# ICHD - ENVIRONMENTAL HEALTH DIVISION

PERMIT # OSWP-2023-18389

## SEPTIC: IMPROVEMENT PERMIT / AUTHORIZATION TO CONSTRUCT / OPERATION PERMIT / EXISTING SYSTEM

| **Description:** | SEE INTERNAL NOTES. Septic field needs repairs. Damaged during pool installation. | | | | |

AS BUILT SKETCH

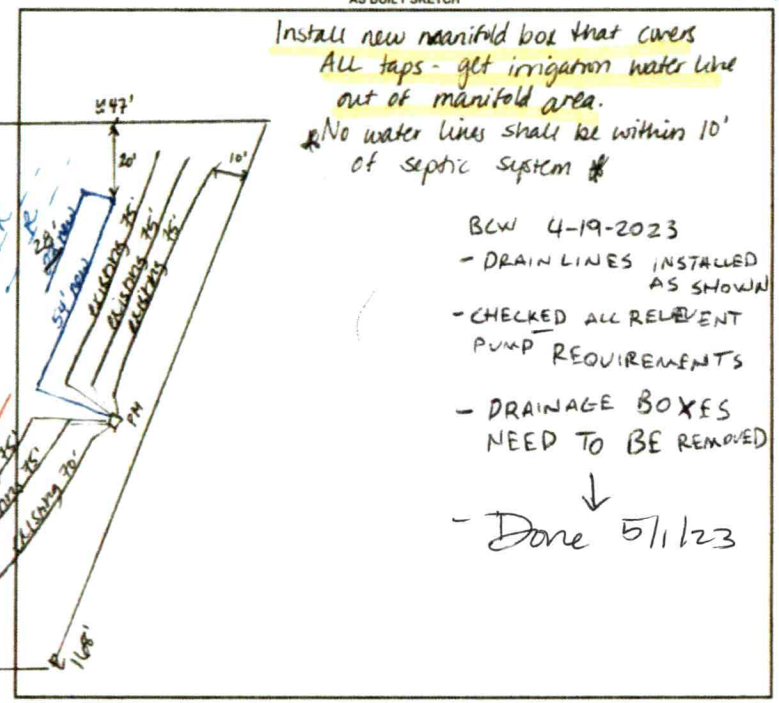
Comments / Conditions: Cap irrigation to back yard - at least 10' from tanks. Move catch basin behind spa so it is 25' from any part of drainfield. Move plumbing from damaged line & connect to new 54' line, feed 22' line below serially. Reset pressure, check alarm, electrical & floats. May vary trench bottom to fit footage as shown.

Install new manifold box that covers ALL taps - get irrigation water line out of manifold area.
*No water lines shall be within 10' of septic system*

BCW 4-19-2023
- DRAIN LINES INSTALLED AS SHOWN
- CHECKED ALL RELEVENT PUMP REQUIREMENTS
- DRAINAGE BOXES NEED TO BE REMOVED
↓
- Done 5/1/23
